Access Compliance Report Public Rights-of-Way (Curb Ramps)

Main Street: AMADO_PL Cross Street: CONTIGO_PL Location: SE

ADA ID: RPRK211117161523 Ramp Type: Type 4 - Parallel Initial Pass/Fail: Pass Overall Compliance: No Severity Score: 6

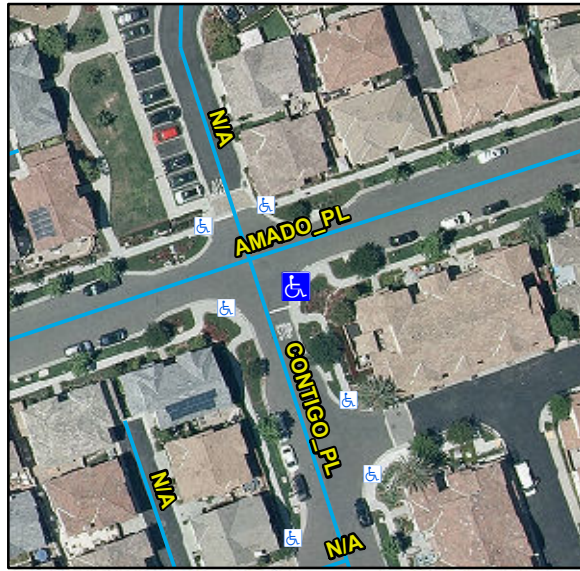
Compliance	Description	Data	Compliance	Description	Data
N/A	Ramp Length LT (in)	113	N/A	Ramp Length RT (in)	113
Yes	Ramp Width LT (in)	53	Yes	Ramp Width RT (in)	53
Yes	Ramp Run Slope LT (%)	5.1	Yes	Ramp Run Slope RT (%)	2.1
Yes	Ramp Cross Slope LT (%)	0.1	Yes	Ramp Cross Slope RT (%)	0.2
N/A	Landing Present	Yes	Yes	DWS Provided	Yes
N/A	Landing Length (in)	53	Yes	DWS Contrast	Yes
Yes	Landing Width (in)	48	Yes	DWS Length (in)	36
Yes	Landing Run Slope (%)	0.2	Yes	DWS Full Width	Yes
No	Landing Cross Slope (%)	2.8		DWS Offset Type	Single
N/A	Landing Movement Obstructed?	No	Yes	DWS Offset Left (in)	0
	Landing Movement Type	Curb	Yes	DWS Offset Right (in)	N/A
N/A	Landing Shared	No			
N/A	Clear Space	Yes			
N/A	Clear Space To Crosswalk (in)	48			
N/A	Marked Crosswalk 1	No	N/A	Marked Crosswalk 2	No
	Crossing 1 Direction	N		Crossing 2 Direction	W
	Marked Crosswalk 1 Width (in)	N/A		Marked Crosswalk 2 Width (in)	N/A
N/A	Ramp Inside Crosswalk 1	N/A	N/A	Ramp Inside Crosswalk 2	N/A

Crossing 1 Slope (%)	2.2		Crossing 2 Slope (%)	0.3
	Crossing 1 Cross Slope (%)	1.7		Crossing 2 Cross Slope (%)	3.4
Yes	Gutter Ponding	No	Yes	Curb Slope	5
Yes	Gutter Lip Height (in)	0		Road Run Slope (%)	1.9
No	Gutter Run Slope (%)	9.6		Road Cross Slope (%)	2.6
No	Gutter Cross Slope (%)	2.8	Yes	Perpendicular Joint Present	Yes
Yes	Overall Surface Condition	Acceptable			
	Cross Gutter Present?	No		Spandrel Present?	No
	Replace Cross Gutter?	N/A		Replace Spandrel?	N/A

Remove & Replace Landing. Remove & Replace Gutter.

R304.5.3, R304.5.4, STD 1115
